Work Order ID 85893

Item Name: 205 Skidtube bent detail

DRAWING NO. D2580	TITLE 205 SKIDTUBE ASSEMBLY	REV. E	DART AEROSPACE LTD ENGINEERING ORDER		D.E.O. NO. D2580-E-1	SHEET NO. SHEET 1 OF 1	SCALE NTS
DRAWN <i>UP</i>	CHECKED <i>ASS</i>	MFG. APPR. <i>EC</i>	APPROVED <i>#</i>	DE APPR. <i>#</i>			
DATE 11.12.13	DATE 11.12.13	DATE 11.12.13	DATE 11.12.13	DATE 11.12.13

CHANGE ALL C'BORED WELDED CROSSBOLT SPACERS TO SWAGED SPACERS

SECTION B-B, F-F, I-I
NOT TO SCALE

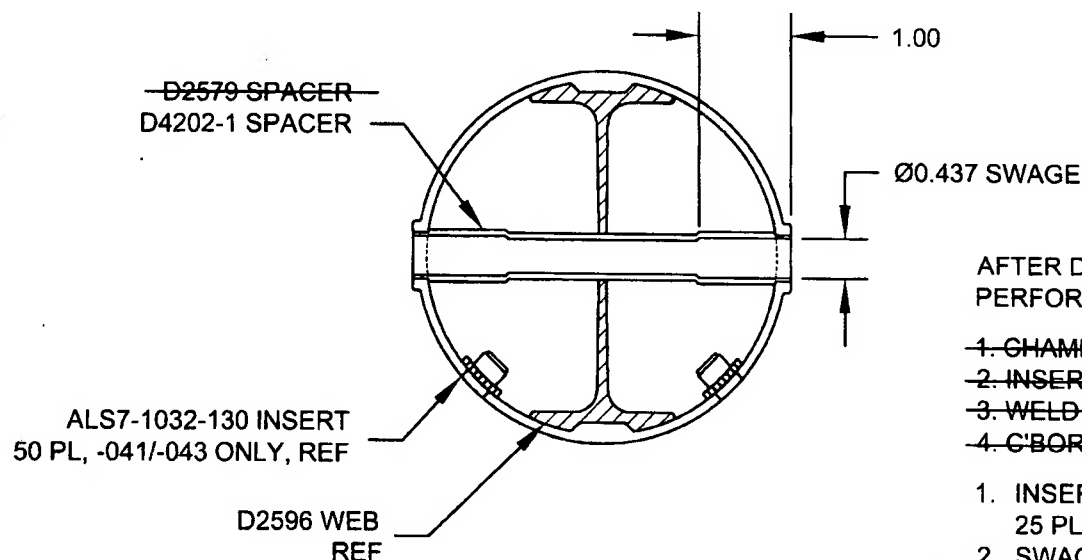
SECTION B-B, SECTION F-F, & SECTION I-I ARE AMENDED AS FOLLOWS
FOR ALL HOLES THAT WERE ORIGINALLY C'BORED:

AFTER DRILLING AND BENDING ASSEMBLY
PERFORM THE FOLLOWING FOR Ø0.508 HOLES ONLY:

1. CHAMFER HOLE 0.050 X 45°
2. INSERT D2579 SPACER (20 PLACES)
3. WELD INTO PLACE AND GRIND FLUSH
4. C'BORE D2579 SPACER TO Ø0.437 X 1.00 DEEP

1. INSERT D4202-1 SPACER, 20 PL (-041) OR 20 PL (-045) OR 25 PL (-047)
2. SWAGE TO Ø0.437 X 1.00 DEEP PER QSI 002
3. TRIM / GRIND FLUSH PER QSI 002
